# UNITED STATES PATENT AND TRADEMARK OFFICE

APPLICATION NO.	FILING DATE	FIRST NAMED INVENTOR	ATTORNEY DOCKET NO.	CONFIRMATION NO.
10/709,715	05/24/2004	Kuo-Hsing Cheng	11586-US-PA	3714

<b>Office Action Summary</b>	<b>Application No.</b> 10/709,715	<b>Applicant(s)</b> CHENG, KUO-HSING	
	<b>Examiner</b> SEOKYUN MOON	<b>Art Unit</b> 2629

## DETAILED ACTION

Drawing 1

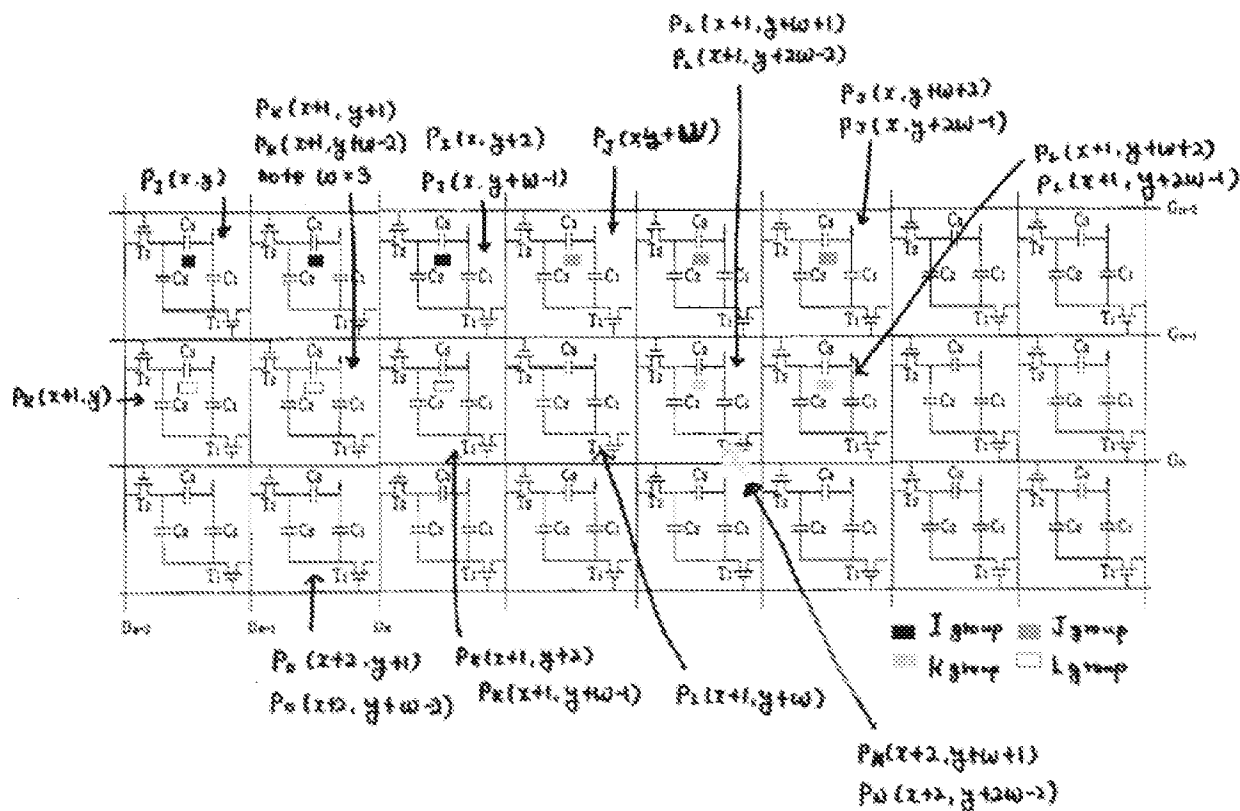
As to **claim 1**, Lee teaches a driving method for a pixel array [fig. 3], at least one row of the pixel array comprising a plurality of pixel sets (note that the display of Lee includes a plurality of parts having a structure shown on fig. 3 and drawing 1 is provided on page 4 of this Office Action for illustration of the plurality of parts having the structure), and at least one of the pixel sets comprising a plurality of pixels (three consecutive pixels), the driving method [drawing 1, which is equivalent to fig. 3] comprising:

driving pixels  $PI(x,y)$ ,  $PK(x+1,y+1)$ ,  $PI(x,y+2)$ , ...,  $PK(x+1,y+W-2)$ ,  $PI(x,y+W-1)$ ,  $PJ(x,y+W)$ ,  $PL(x+1,y+W+1)$ ,  $PJ(x,y+W+2)$ , ...,  $PL(x+1,y+2W-2)$ ,  $PJ(x,y+2W-1)$  by a first gate line (" $Gn-I$ "), wherein  $K$ th,  $J$ th, and  $L$ th pixel sets adjacent to the  $I$ th pixel set comprise  $W$  pixels respectively, wherein a  $I$ th pixel set comprises  $W$  pixels, a pixel of the  $I$ th pixel set in  $x$ th row and  $y$ th column is expressed as  $PI(x,y)$  and  $I$ ,  $W$ ,  $x$ ,  $y$ ,  $K$ ,  $J$ , and  $L$  are integers; and

driving pixels,  $PK(x+1,y)$ ,  $PO(x+2,y+1)$ ,  $PK(x+1,y+2)$ , ...,  $PO(x+2,y+W-2)$ ,  $PK(x+1,y+W-1)$ ,  $PL(x+1,y+W)$ ,  $PN(x+2,y+W+1)$ ,  $PL(x+1,y+W+2)$ , ...,  $PN(x+2,y+2W-2)$ ,  $PL(x+1,y+2W-1)$  by a second gate line (" $Gn$ "), wherein  $O$ th and  $N$ th pixel sets adjacent to the  $K$ th and  $L$ th pixel sets comprise  $W$  pixels, and  $O$ ,  $N$  are integers.

Lee does not expressly teach the method comprising providing a plurality of voltages having substantially same phase to a plurality of pixel electrodes of the pixels of one of the pixel sets and providing at least two voltages with phases substantially opposite to each other to the pixel electrodes of the pixels of two of the adjacent pixel sets respectively.

However, Noguchi teaches a concept of using three-dots polarity inversion method to drive a liquid crystal display panel [col. 12 lines 32-36], wherein the three-dots polarity inversion method provides a plurality of voltages having substantially same phase to a plurality of pixel electrodes of the pixels of a pixel set (the pixel set comprising R, G, B pixels) and provides at least two voltages with phases substantially opposite to each other to the pixel electrodes of the pixels of two of the adjacent pixel sets respectively.

It would have been obvious to one of ordinary skill in the art at the time of the invention to modify the driving method of Lee to use three-dots polarity inversion method, as taught by Noguchi, in order to prevent changes on the polarizations of liquid crystals caused by applying data voltages having same polarity to the pixels for a long time period.

As to **claim 2**, Lee as modified by Noguchi teaches each of the pixel sets comprising three pixels [drawing 1 provided above].

As to **claim 3**, Lee as modified by Noguchi teaches a number of the pixels of each of the pixel sets being  $3 \times M$ , wherein  $M$  is a positive integer [drawing 1 provided above].
